Product / Process Change Notification (PCN)

PCN Number: PCN_FeSAFB_20250101

Affected Series: WE-SAFB

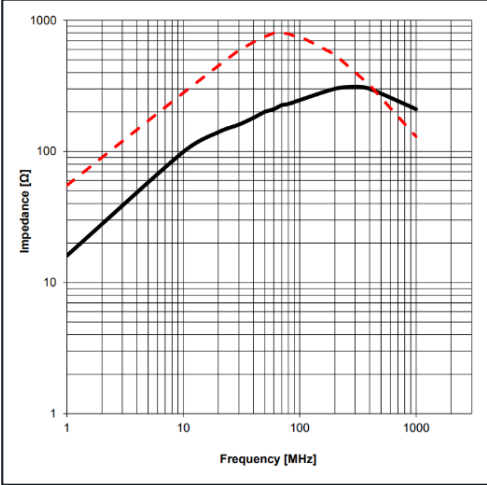
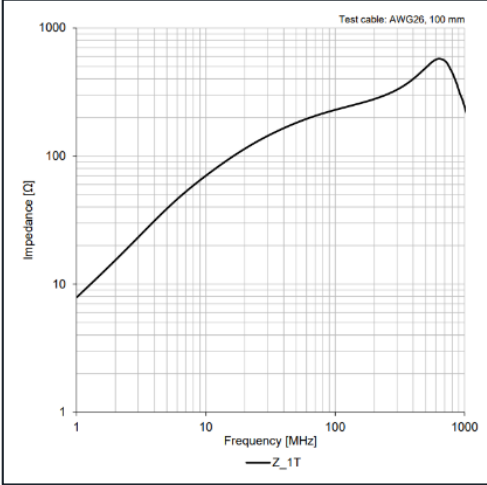
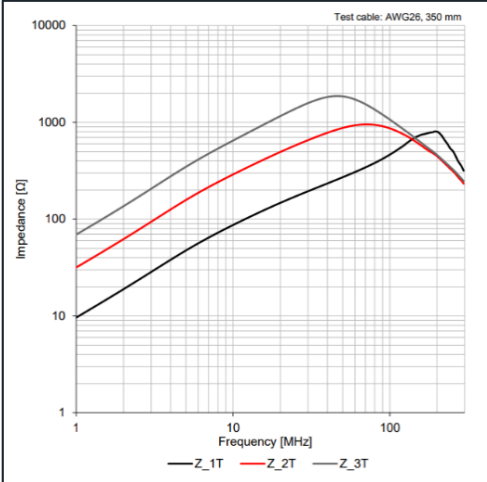
3. The visualization of chart for the “**Typical Impedance Characteristics**” changes. The used type of cable and cable length is shown in each chart.

| Before change: | After change: |
|---|---|
| <ul style="list-style-type: none"> Showing only one graph with 1 turn (1T) and 2 turns (2T) impedance curves.  | <ul style="list-style-type: none"> Showing a graph for the 1 turn (Z_1T) impedance curve with the shortest possible cable length according to the product.  |
| <ul style="list-style-type: none"> Showing no graph with 3 turns impedance curve. | <ul style="list-style-type: none"> Showing a graph for 1-3 turns (Z_1T, Z_2T, Z_3T) impedance curves with the shortest possible cable length, which is required for 3 turns according to the product.  |
